Response to Further Information Request (FIR)

12/09/2017

The NIS states that "the footprint of the Stage 6 facility is confined to the existing northern and seven fields borrow areas. Virtually all the area is exposed indicating rock or glacial till over the site". The EIS states that "... a resistivity and microgravity survey would be undertaken to delineate the presence of any palaeokarstic features..."

Figure 1: Probability of Seepage from Composite Lining System

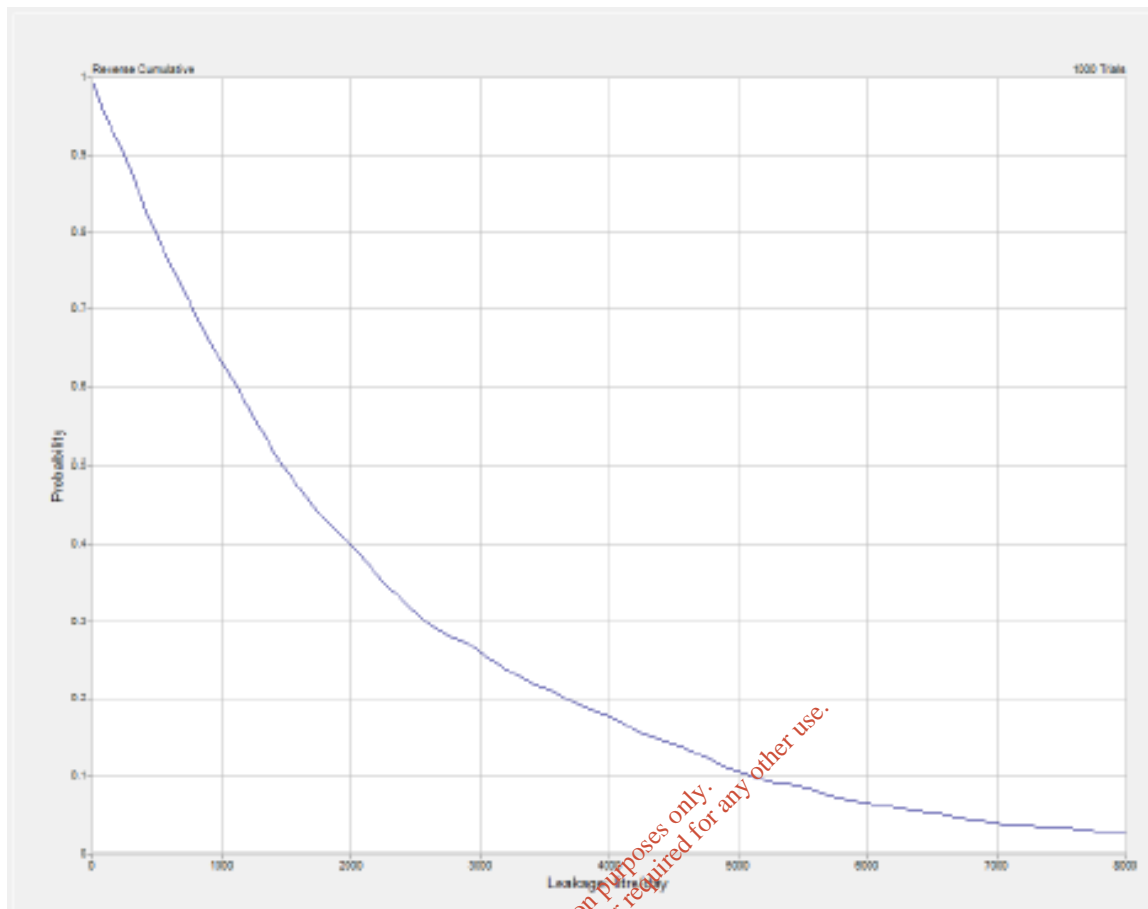
- a) Please provide a seepage analyses model and 2D sections through the proposed TMF as part of the stability analysis.*
- b) Provide explanation why there is no allowance for an over liner and underliner drainage as part of seepage control during operation.*

The volume of seepage flowing laterally through the dam wall via the GCL and some nominal defects in the lining system for a constant head of 20m (Phase 2) would be an average of about 1.5 m³/day with a 10% probability of the seepage being less than 0.25 m³/day and a 10% probability being greater than 5 m³/day. The range represented in the figure below, is based on a number of variables including infiltration rate based on the range of vertical permeability values of the tailings, the range of defects in the lining per hectare, the effective permeability of the composite lining and head acting on the lining.

The dam wall incorporates a basal granular drainage blanket and the downstream dam shell has been modified to be granular. Thus any seepage through the dam wall will be directed to the drainage blanket. Seepage through the basin will pass into the underlying limestone. It is not therefore not appropriate to undertake a seepage model under these circumstances.

Figure 2 Stage 6 Tailings Deposition Plan

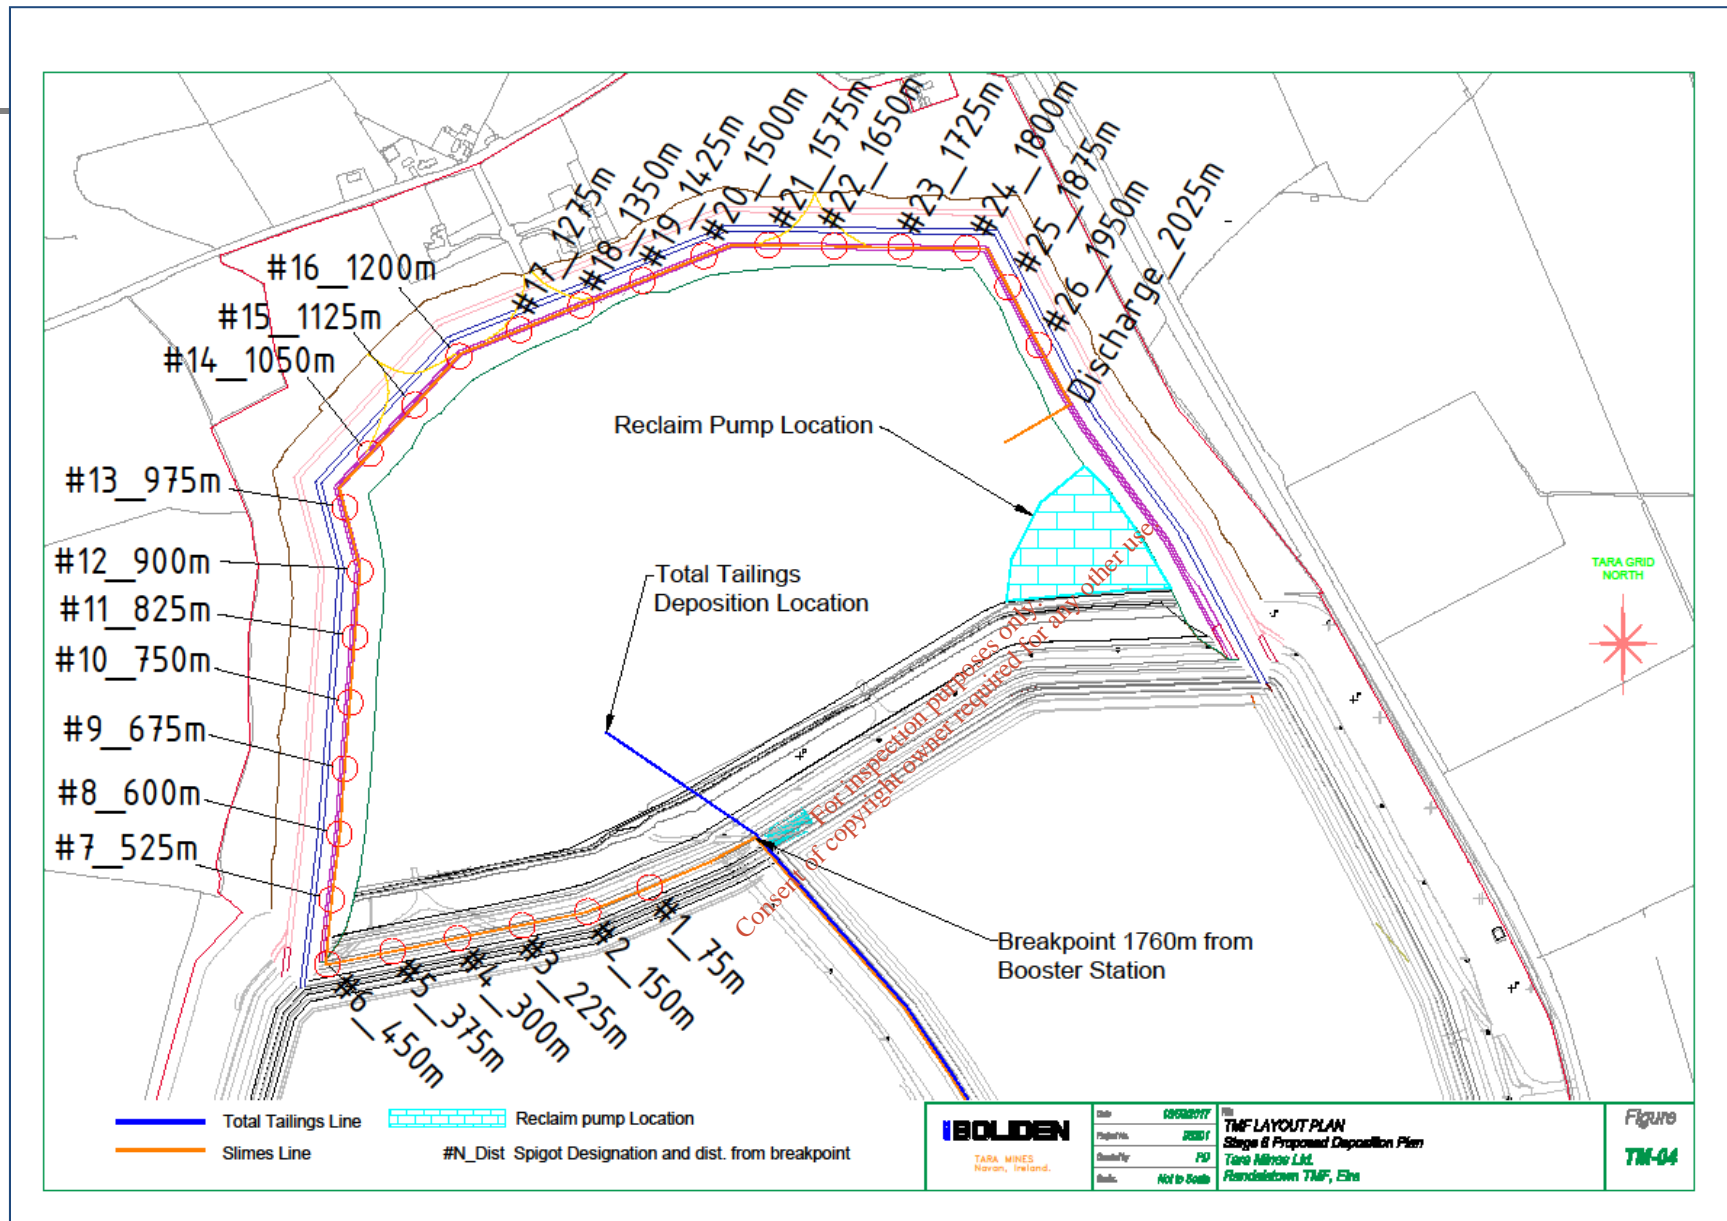
a) Provide a tailings deposition plan detailing the layout of the tailings pipeline, deposition points, decant location and technical specifications of the pipeline (including proposed pipe cross-section and long section).

The tailings deposition systems for the Stage 6 crest are detailed in Figure 2, including spigot locations and long section (figure 3). The main header pipeline carrying the tailings is 800 mm OD, 559 mm ID, PE100 and SDR17. The spigot spacings will be at 75m. The tailings discharge pipe line at the spigots is 200 mm OD, 176 mm ID, PE 100 and SDR17. A typical spigot point is presented in Figure 4 below

Figure 3: Residual Bouguer Gravity Map with Borehole Locations (red circles)

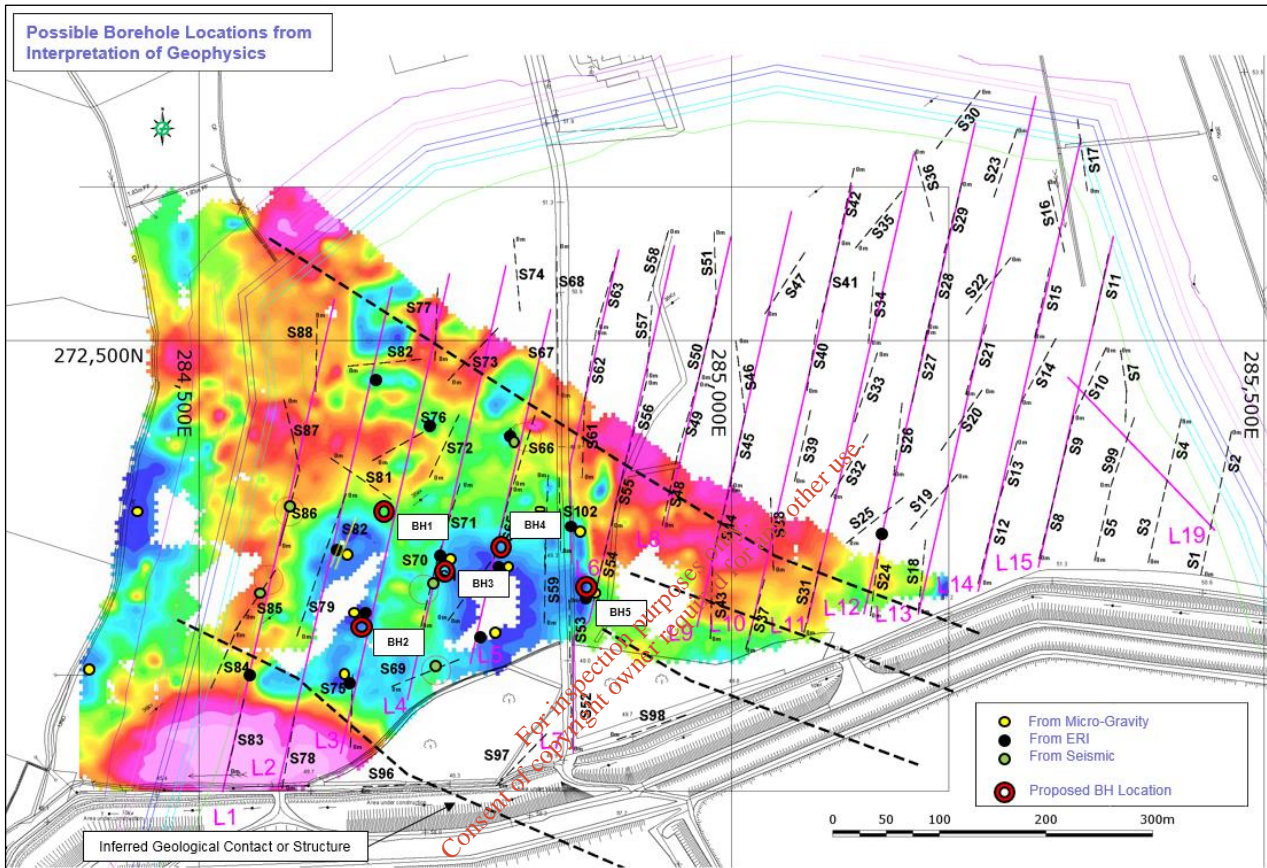
- a. Please provide a report of a comprehensive study of palaeokarst features and their potential impact on Stage 6 TMF stability. The study and report should detail the following as a minimum; site investigation plan, geotechnical logs, soil and rock laboratory testing, tailings geotechnical characterisation, geological plan and sections, and geotechnical parameters.
- b. Table 5.1 of the EIS details the geotechnical parameters adopted in the stability modelling. Please compare these modelling parameters to the parameters obtained from the study requested in paragraph 1a above. A sensitivity analysis (undertaken to assess any potential variation in parameters for soil foundation, tailings and embankment construction material), should be included in the report requested in paragraph 1a above.

Results from the **Micro-Gravity** survey identified a number of gravity lows (Figure 3), indicating the possible presence of areas with 'low density sub-crop material'. These gravity low areas may be due to palaeokarstic

None of the anomalies interpreted are located beneath the dam wall footprint, all five are located in the south-west section of the base of the proposed Stage 6 TMF.
